UN Regulation No. 46 (Devices for indirect vision)

Proposal for the 05 series of amendments of UN Regulation No. 46

**Submitted by the expert from Germany and by the expert from the
International Organization of Motor Vehicle Manufacturers ***

**Figure 1
 Example for the measurement by maximum variation**

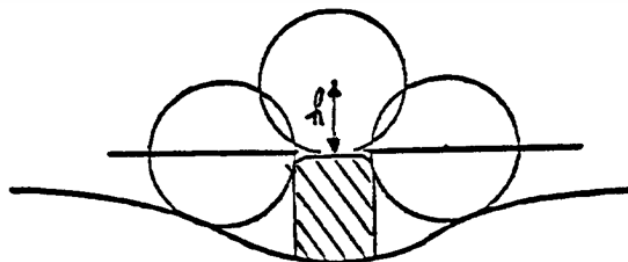
Insert a new paragraph 6.2.2.1.2.2., to read:

"6.2.2.1.2.2. If the dimension of the projection of a component which is mounted on a surface other than convex cannot be determined by simple measurement, it shall be determined by the maximum variation of the distance of the centre of a 100 mm diameter sphere from the nominal line of the panel when the sphere is moved over and is in constant contact with that component. Figure 1 shows an example of the use of this procedure.
